ADAMSTOWN BOULEVARD DEVELOPMENT:

ADAMSTOWN BOULEVARD PHASE 1

SDCC REG. REF. SDZ22A / 0007

SUBMISSION ON COMPLIANCE WITH CONDITION No. 34

Site	ADAMSTOWN BOULEVARD
Project	ADAMSTOWN BOULEVARD - COMPLIANCE NO. 34
Title	WESTERN BIODIVERSITY AREA (REVISED COMPLIANCE)

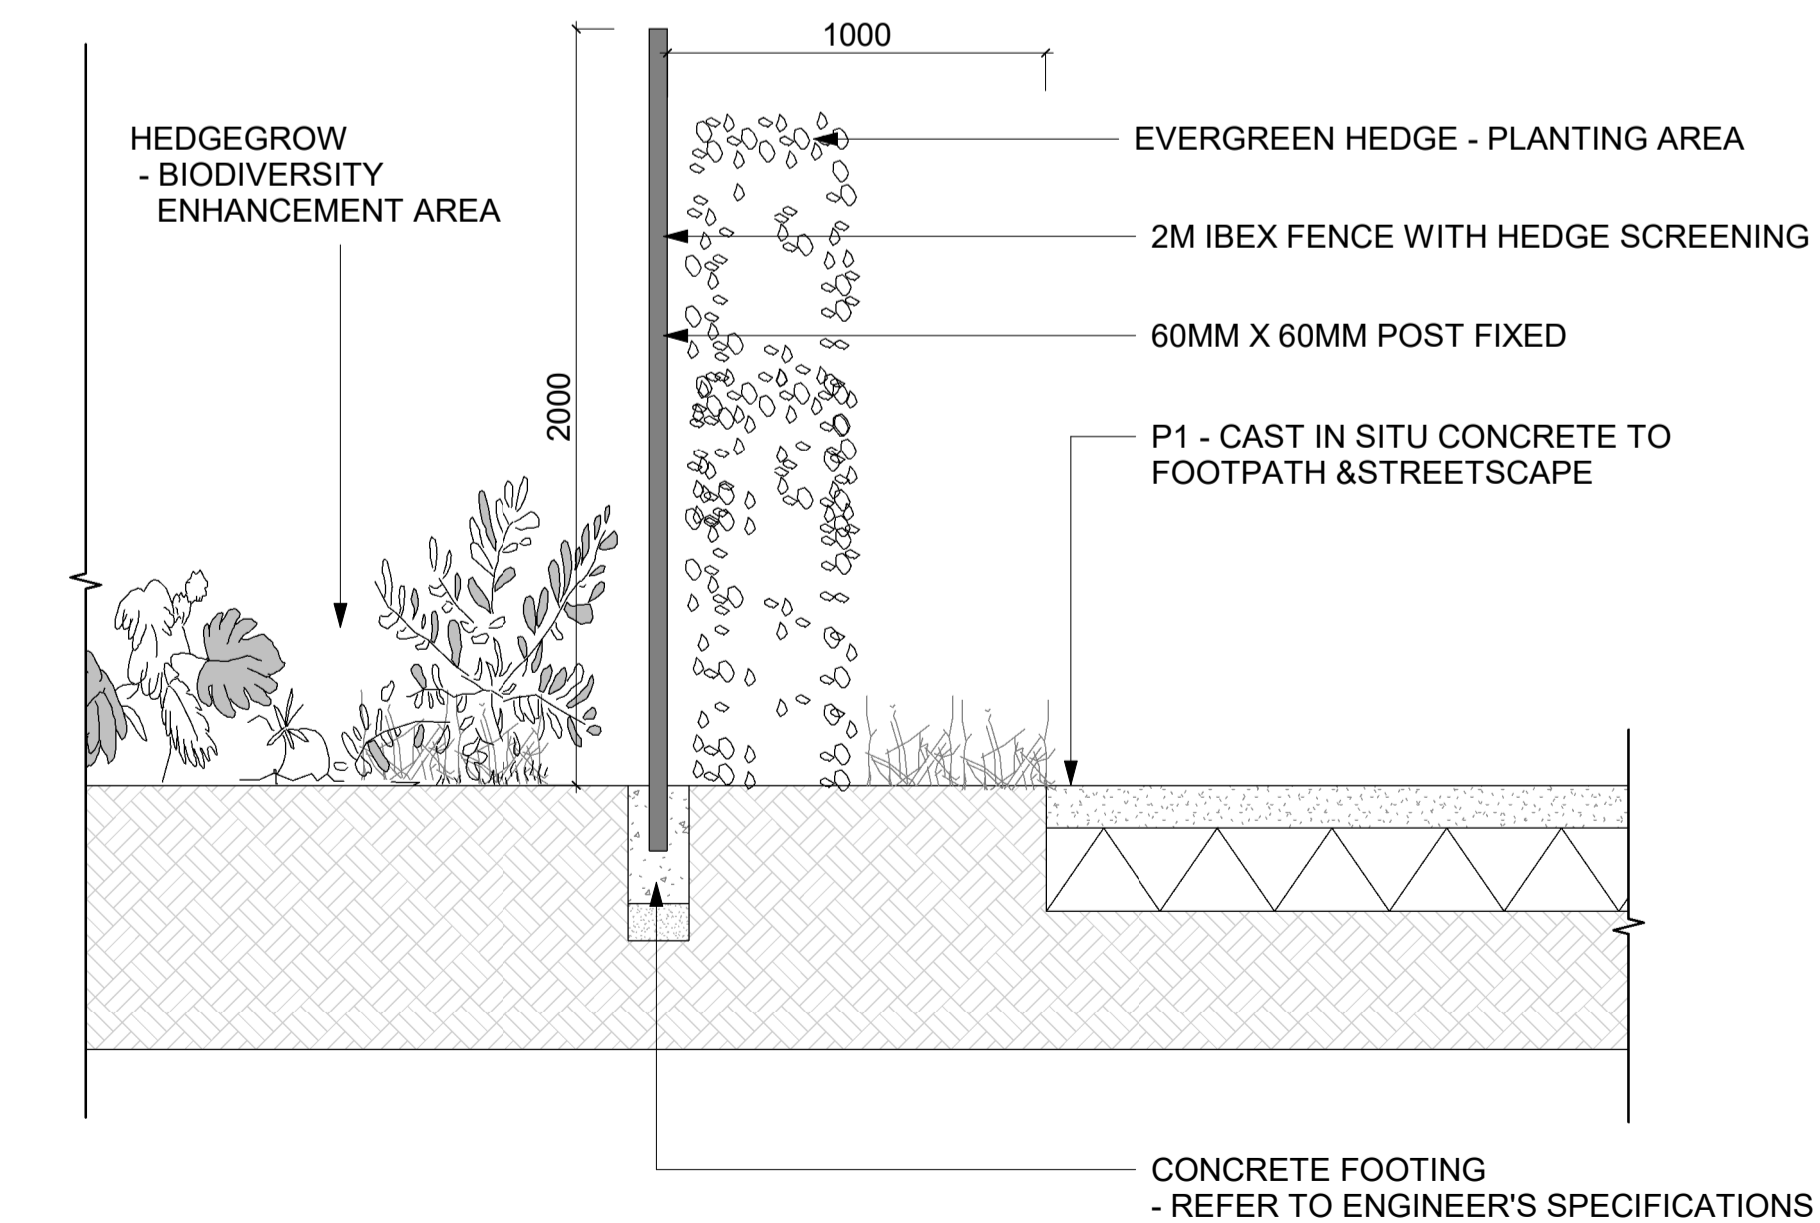
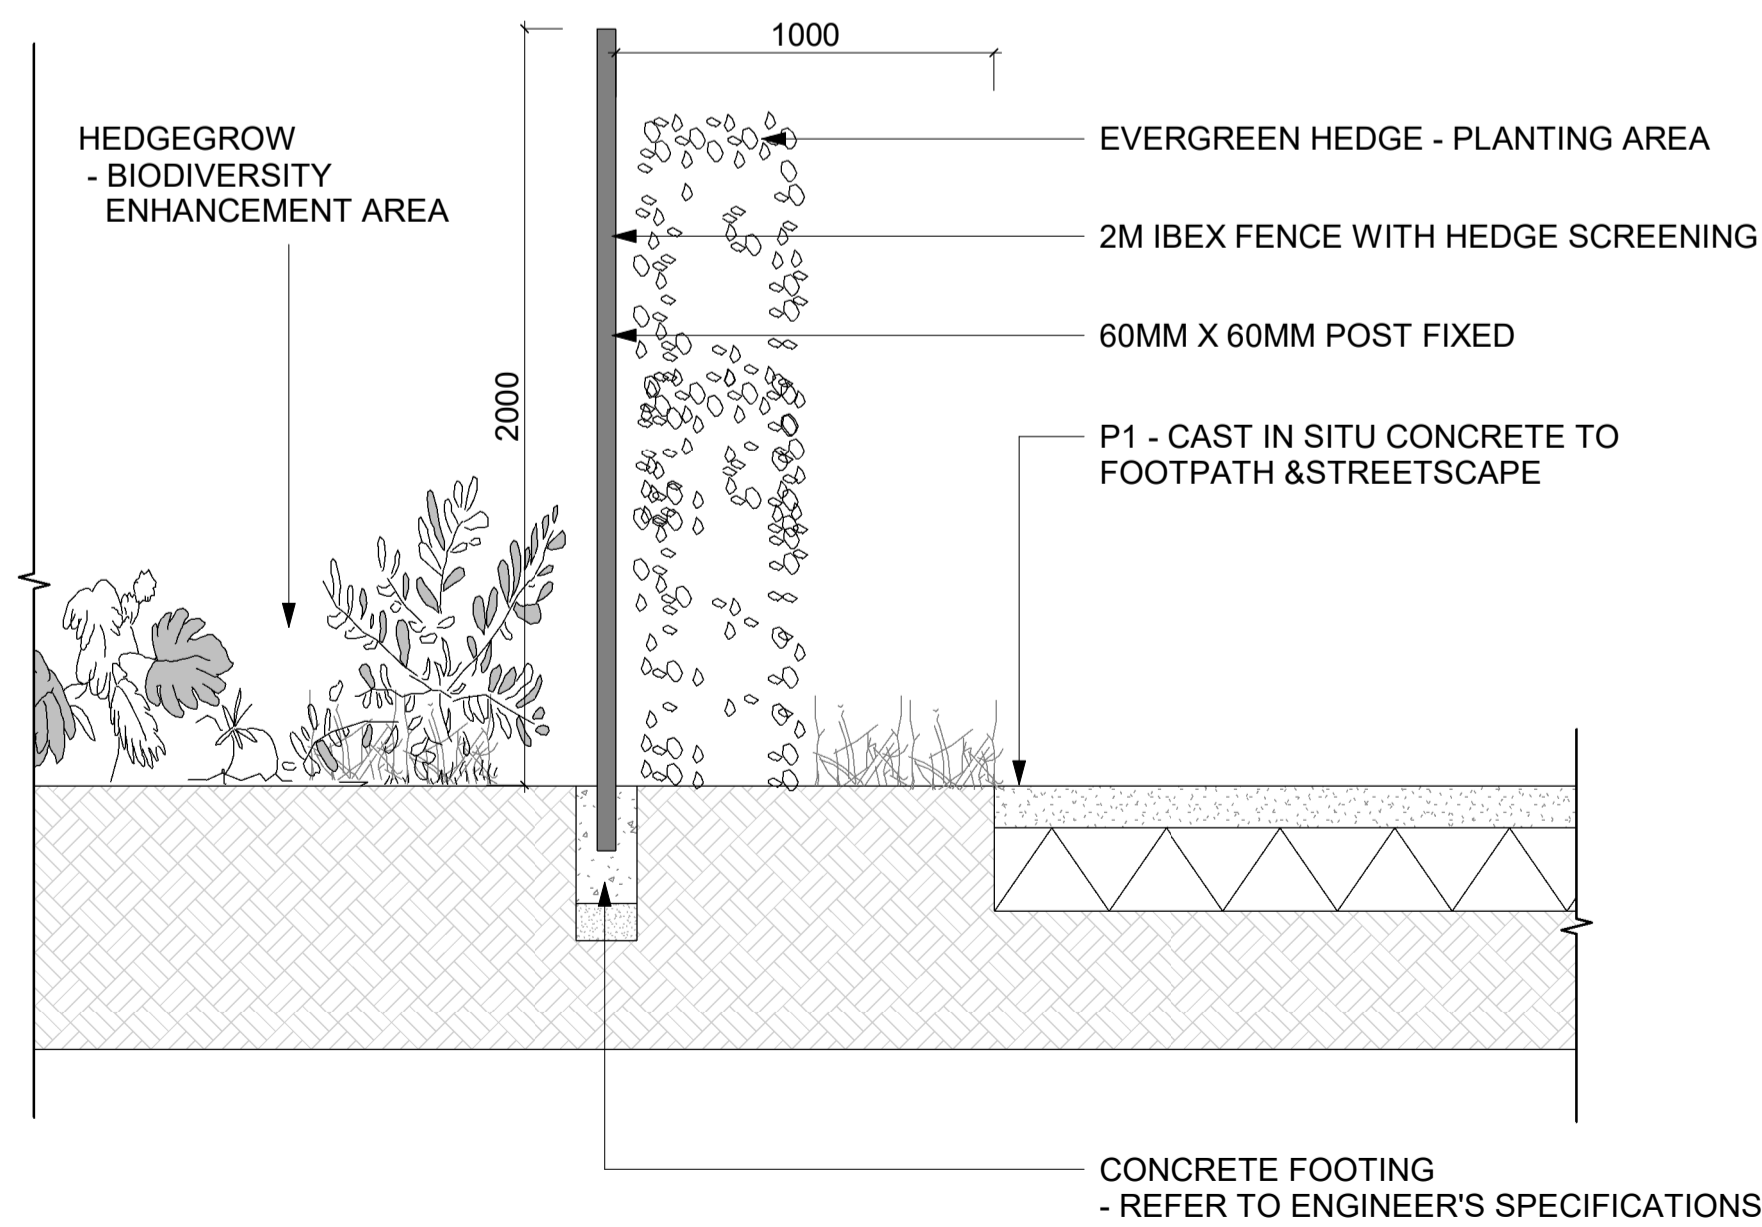
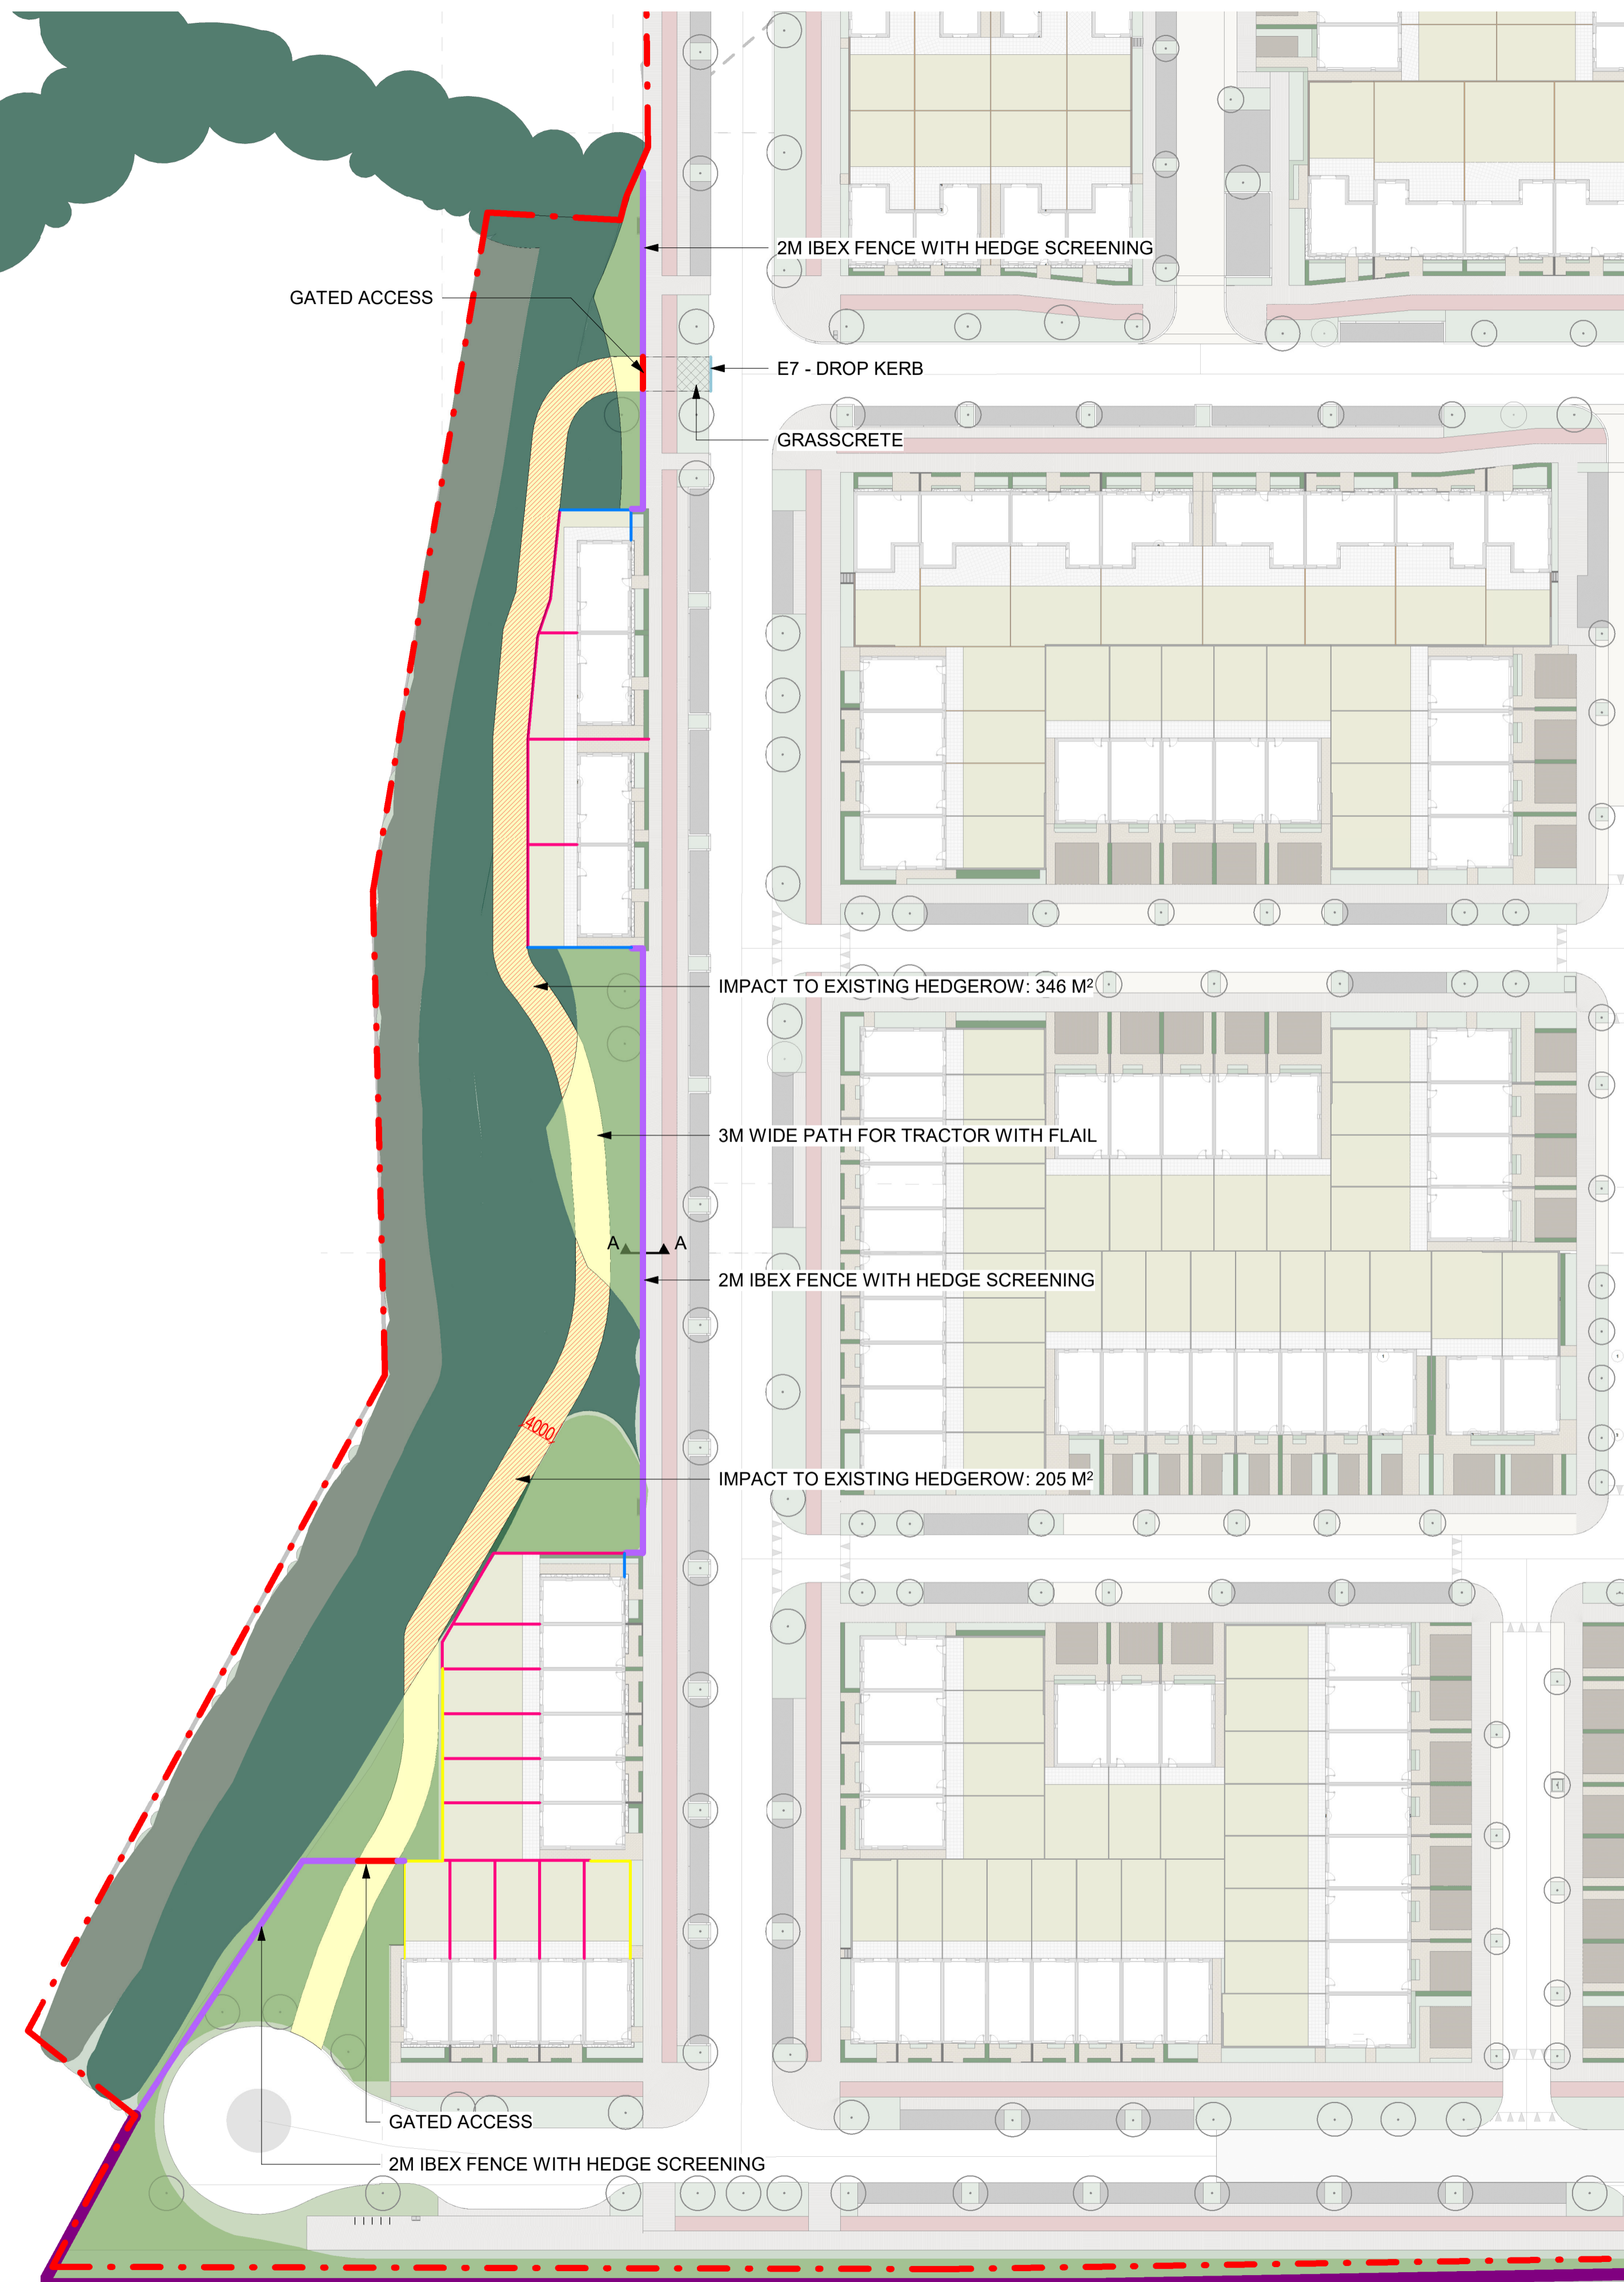
- The maintenance path has been modified to eliminate the sharp turn for the tractors.
- The maintenance path has been redirected closer to the gate access that opens onto - Adamstown Avenue. A grasscrete system is introduced to preserve the existing planting, and a drop kerb is added to facilitate road access for the tractors.

Management plan for biodiversity area:

- Introduce 3m (W) compacted aggregate path to the rear of the back gardens boundary, plus additional meter between the path and the hedgerow (4m total). Exact offset and location of path to be confirmed by SDCC maintenance personnel. The 3m path is of sufficient width to facilitate access from a tractor and flail for maintenance purposes.

- Protection of the hedgerow access path with introduction of 2m (H) IBEX fence to be screened from public with evergreen hedge planting. One gate to be at either end so cutting can be done in one straight run.

- The path impacts the existing hedgerow by removing an additional 551 m² of hedgerow from which was specified in the planning application (reference DWG. NO. L1-103 - HEDGEROW MITIGATION)

- The total area of the drawn path (shown in yellow) is 840 m². Of this amount, 551 m² is reduced from the existing hedgerow (yellow with red stripes) while 290 m² is reduced from the mitigation biodiversity area.
